The Cedar Court -- [Plan W-5004]

Acknowledgement Of Plans Submittal ONLY!

First Floor Plan

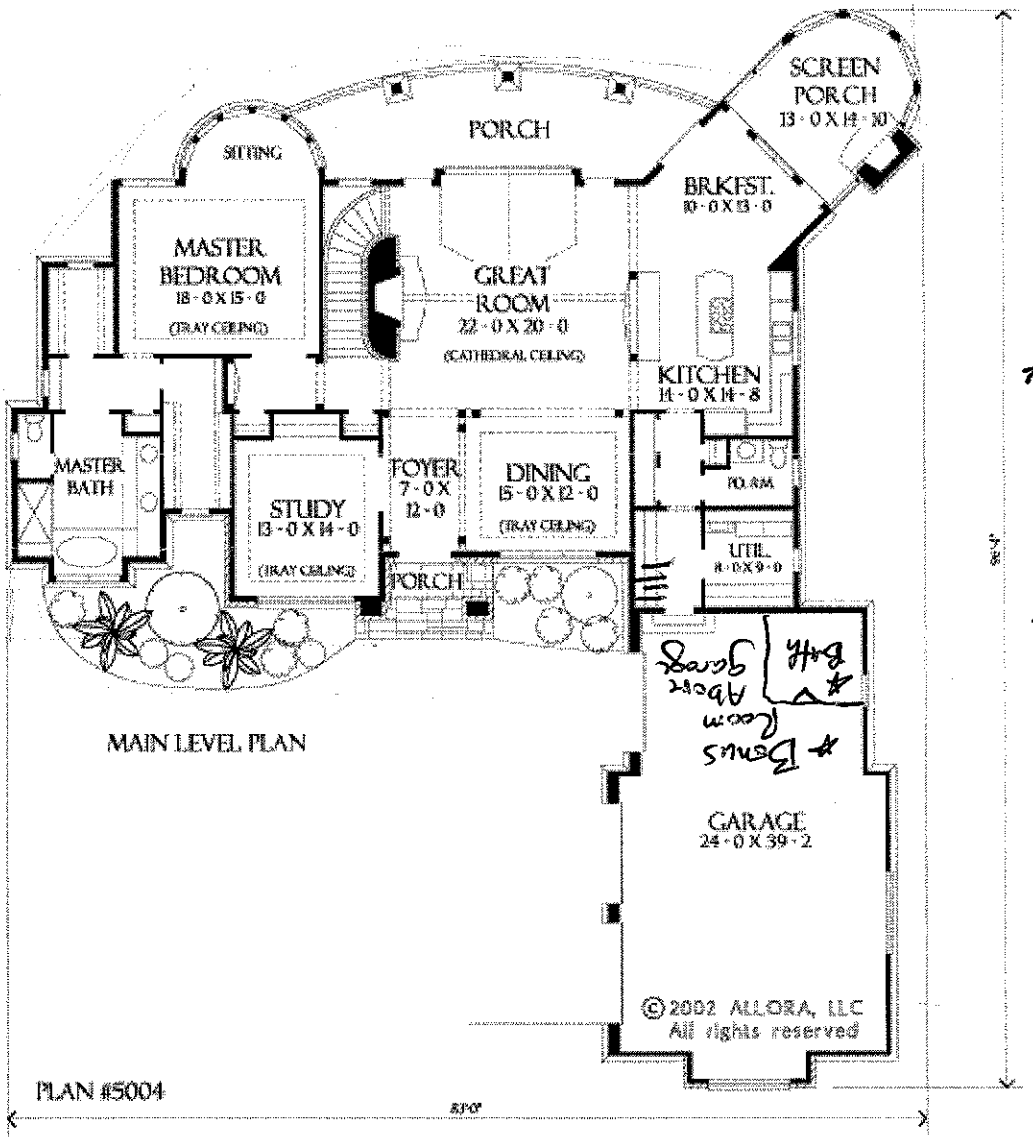
* Rooms added after initial plan

Builder submitted letter to state added rooms have windows which do not meet egress. (Bonus Rm) see attached & notes

Basement Floor Plan

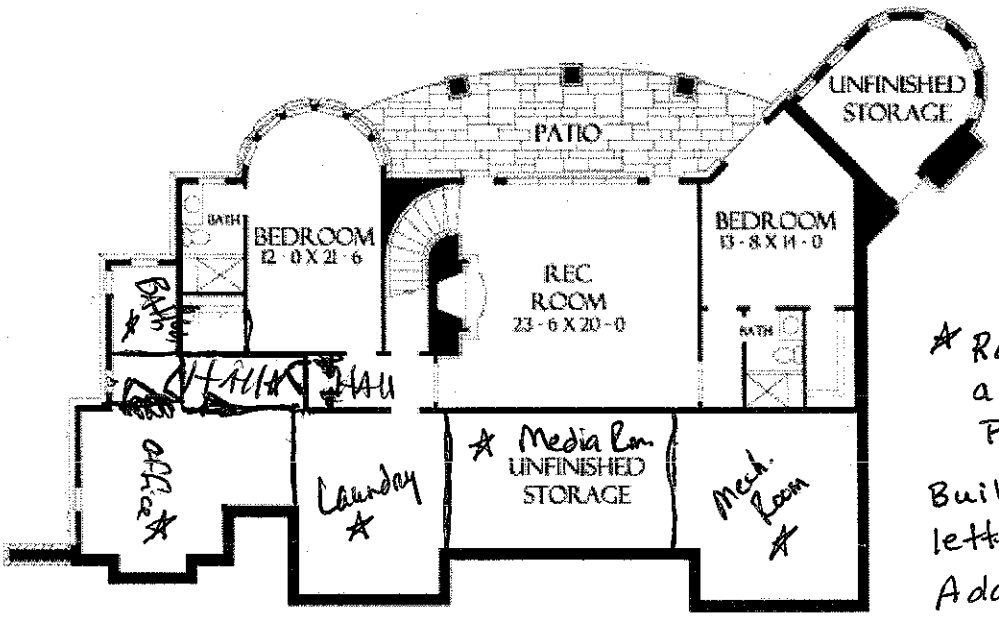
★ Rooms added after initial Plan

Builder submitted letter to state Added rooms - office, Bonus Rm - have windows which do not meet egress. See Attached
